Form 3160-5
(June 2019)UNITED STATES
DEPARTMENT OF THE INTERIOR
BUREAU OF LAND MANAGEMENTFORM APPROVED
OMB No. 1004-0137
Expires: October 31, 2021**SUNDRY NOTICES AND REPORTS ON WELLS**
Do not use this form for proposals to drill or to re-enter an abandoned well. Use Form 3160-3 (APD) for such proposals.

8. Well Name and No. HAWK 35 FED/305H

Hawk 35 Fed 305H API #: 30-025-48086

EOG respectfully requests an amendment to our approved APD for this well to reflect the following changes:

WELL LOCATION AND ACREAGE DEDICATION PLAT

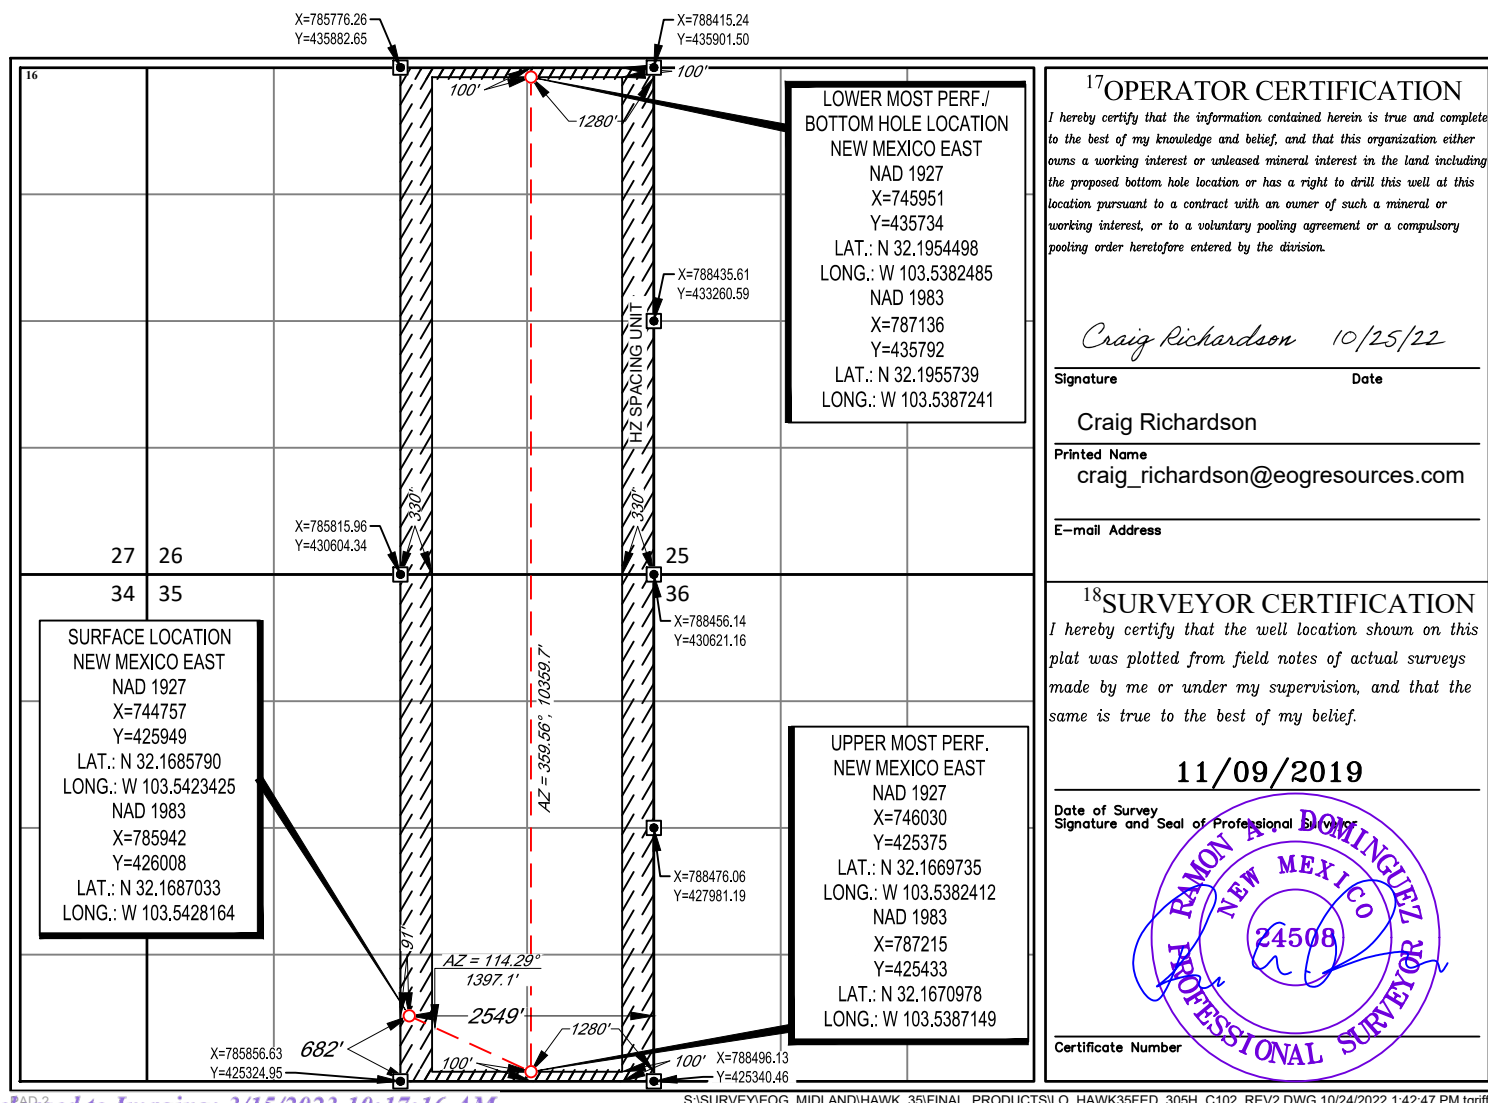
Change SHL from T-24-S, R-33-E, Sec 35, 742' FSL, 2444' FEL, Lea Co., NM,
to T-24-S, R-33-E, Sec 35, 682' FSL, 2549' FEL, Lea Co., N.M.

Change BHL from T-24-S, R-33-E, Sec 26, 100' FNL, 2330' FEL, Lea Co., NM,
to T-24-S, R-33-E, Sec 26, 100' FNL, 1280' FEL, Lea Co., N.M.

UL or lot no.	Section	Township	Range	Lot Idn	Feet from the	North/South line	Feet from the	East/West line	County
0	35	24-S	33-E	—	682'	SOUTH	2549'	EAST	LEA

UL or lot no.	Section	Township	Range	Lot Idn	Feet from the	North/South line	Feet from the	East/West line	County
A	26	24-S	33-E	—	100'	NORTH	1280'	EAST	LEA

Figure 1: Cameron TA Plug and Offline Adapter Schematic

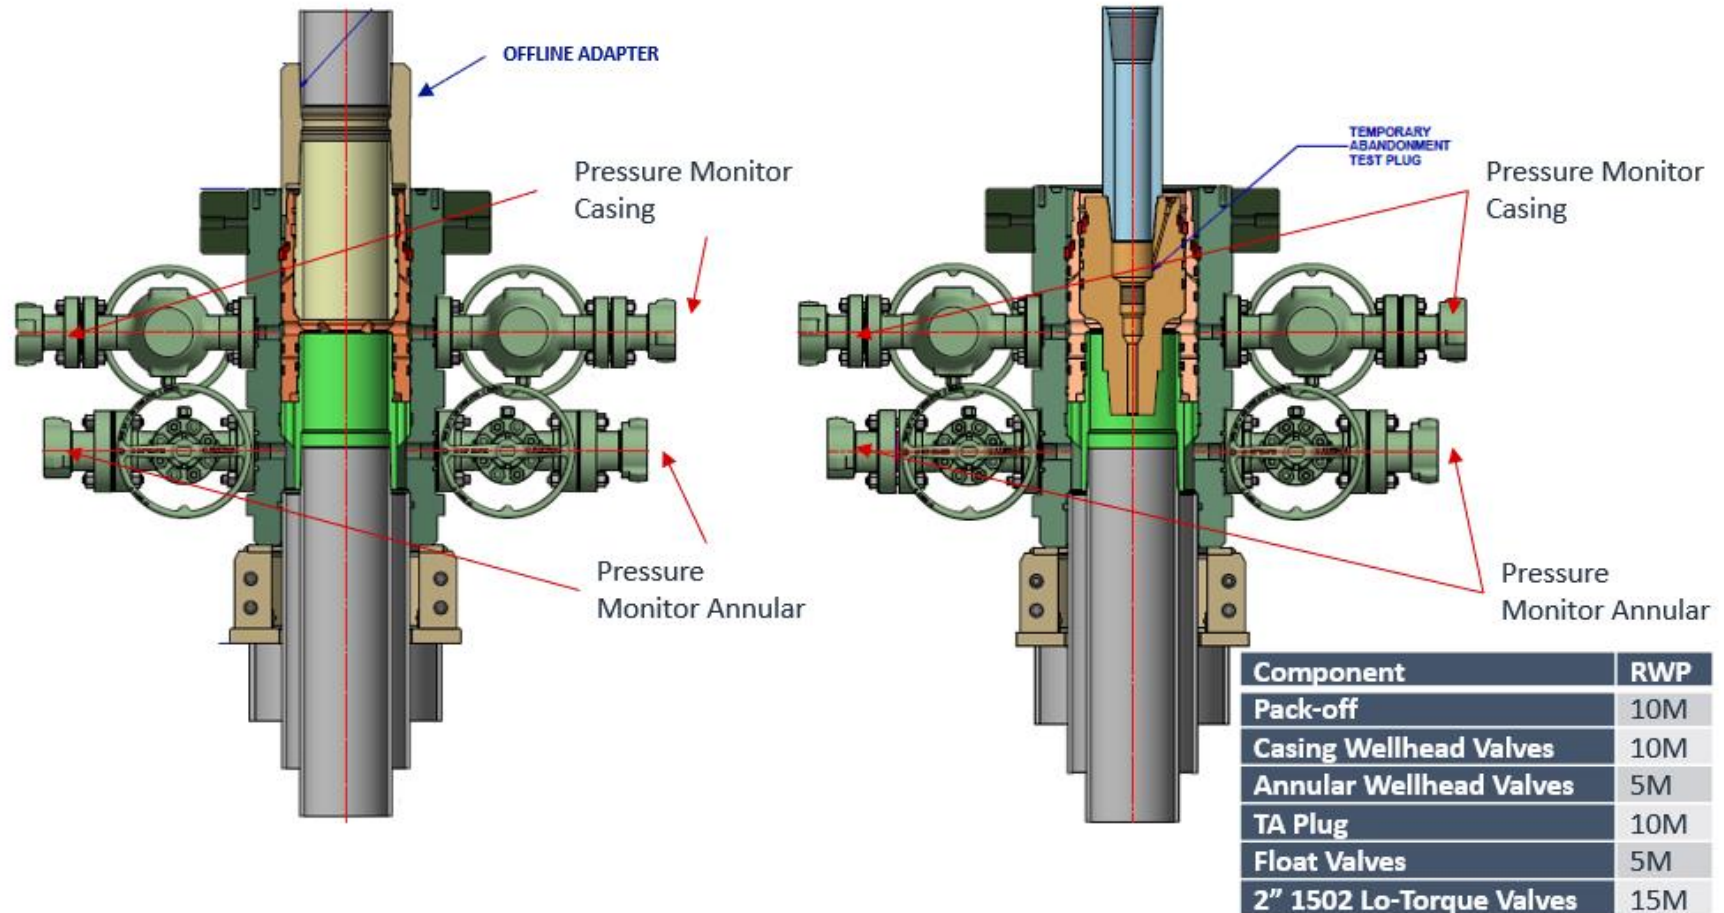
- c. Return line schematics can be seen in Figure 3.
10. Remove TA Plug from the casing.
11. Install offline cement tool.
 - a. Current offline cement tool schematics can be seen in Figure 1 (Cameron) and Figure 2 (Cactus).

Figure 4: Rig Placement Diagram

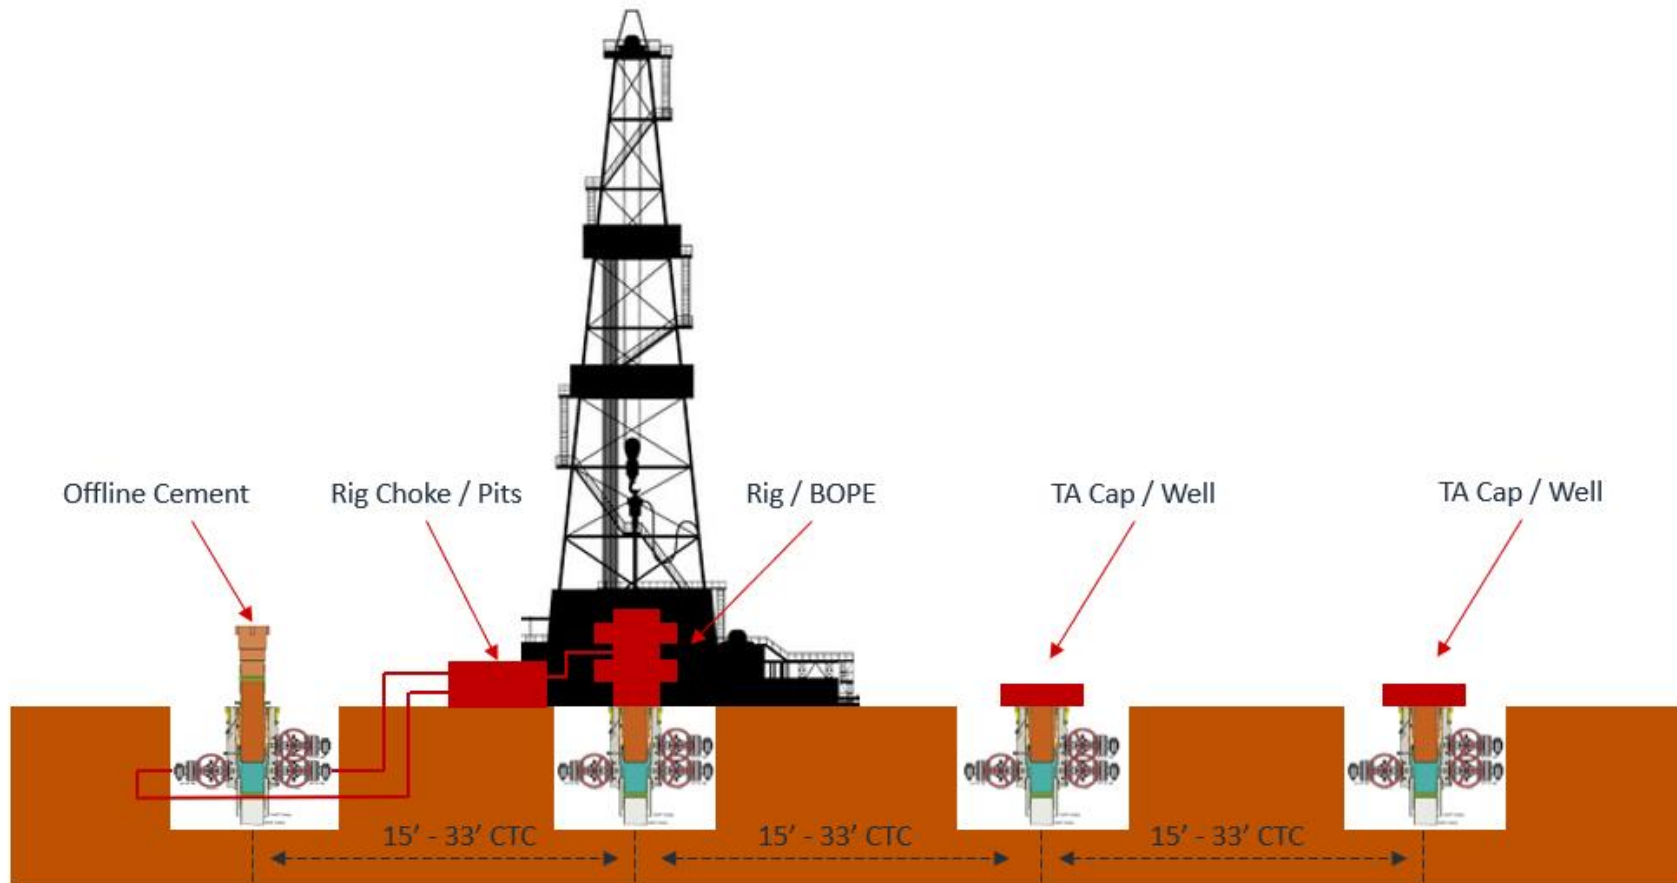
- e. Diagram for rig positioning relative to offline cementing can be seen in Figure 4.
9. Rig up return lines to take returns from wellhead to pits and rig choke.
